MONTGOMERY COUNTY HISTORIC PRESERVATION COMMISSION
STAFF REPORT

| Address: | 3 West Lenox St., Chevy Chase | Meeting Date: | 3/11/2020 |
| Case Number: | 35/13-20I | Staff: | Michael Kyne |
| PROPOSAL: | Fenestration alterations | | |

Silverthorne & Lashway Home
North Facade – Second Floor Detail
3 W Lenox St, Chevy Chase, MD 20815

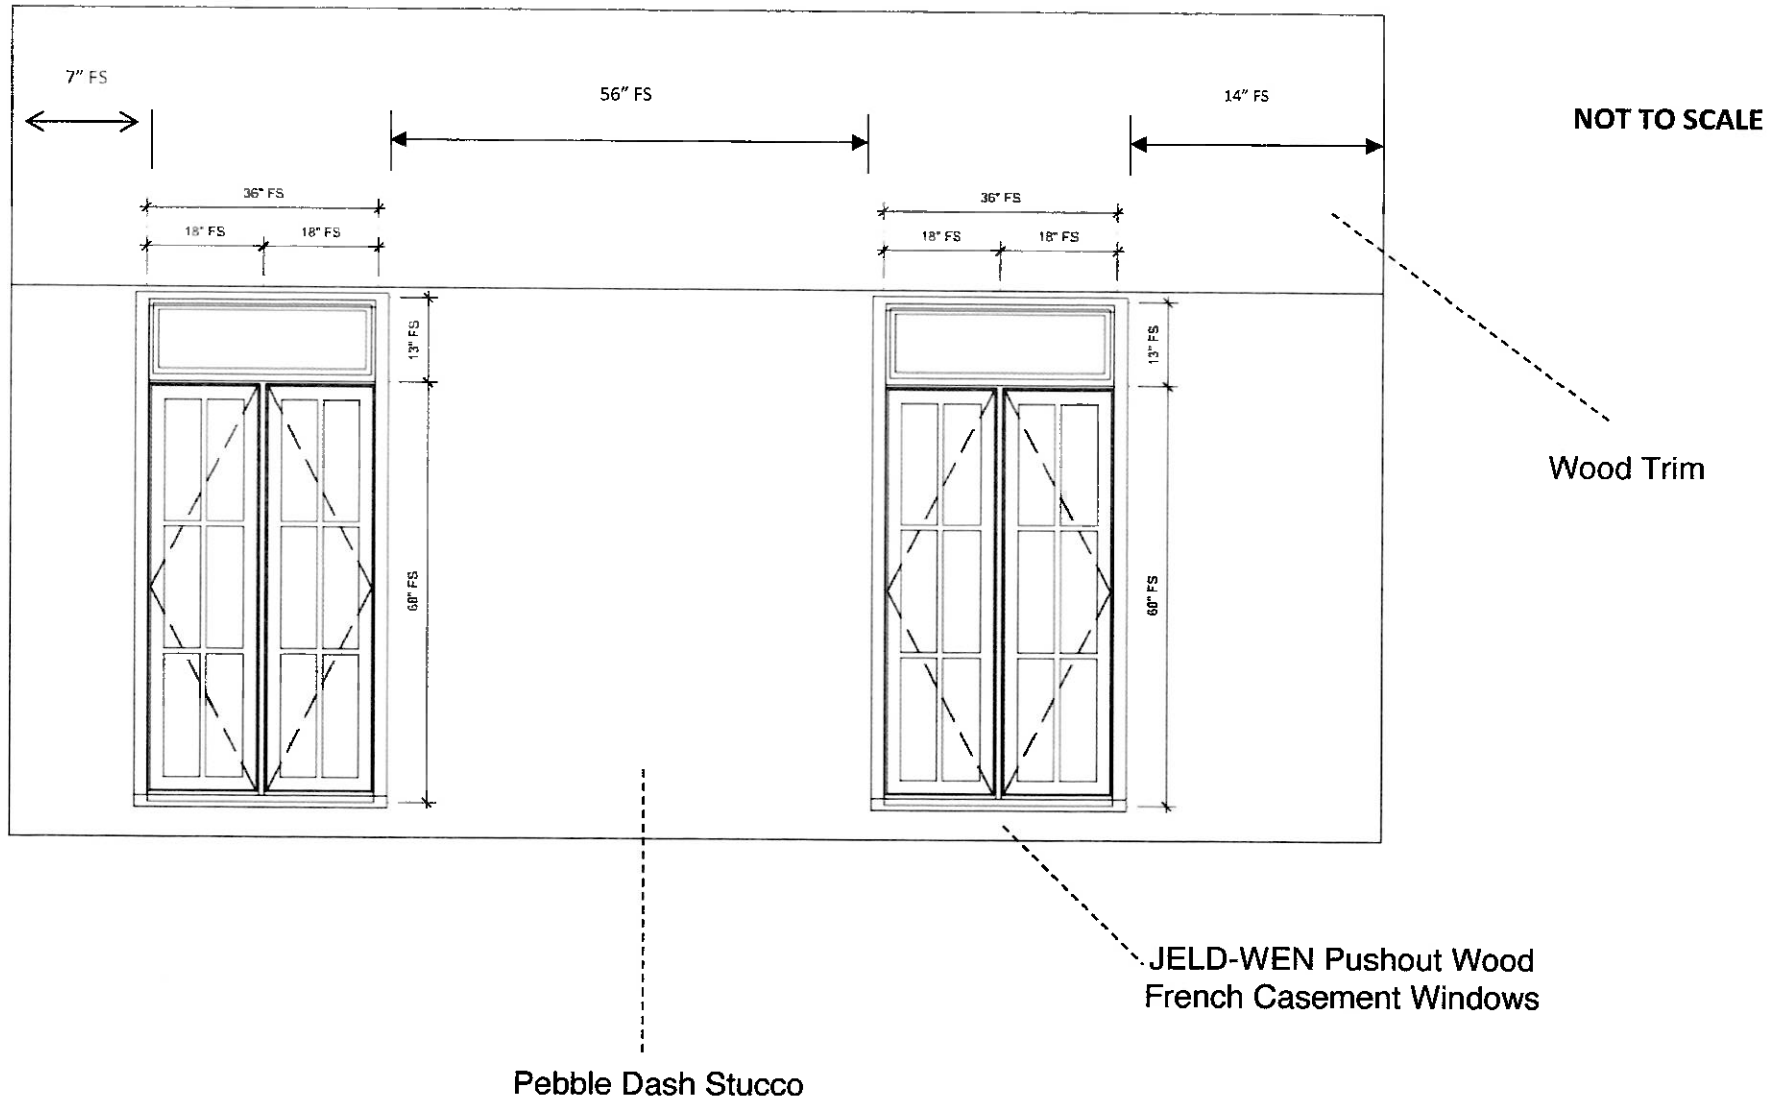
The subject property is a c. 1892-1916 Colonial Revival-style Contributing Resource within the Chevy Chase Village Historic District. The applicants propose to replace the existing French doors on the second floor of the rear elevation with new wood casement windows and infill transoms.

Staff supports the applicants' proposal. The proposed fenestration alterations are at the rear of the property, where they are not visible from the public right-of-way. The *Guidelines* state that "[a]lterations to the portion of a property that are not visible from the public right-of-way should be subject to very lenient review. Most changes to rear of the properties should be approved as a matter of course." Additionally, the proposal alterations are designed in such a way that the property still contributes to the historic district. In accordance with *Standards #2* and *#9*, the proposal will not remove or alter character-defining features of the subject property. There is another door which leads onto this balcony, so the area will continue to function as usable space.

Staff recommends that the Commission **approve** the HAWP application only for alterations to the main house under the Criteria for Issuance in Chapter 24A-8(b) 1 and 2, (c), and (d), having found that the proposal is consistent with the *Chevy Chase Village Historic District Guidelines* identified above, and therefore will not substantially alter the exterior features of the historic resource and is compatible in character with the district and the purposes of Chapter 24A;
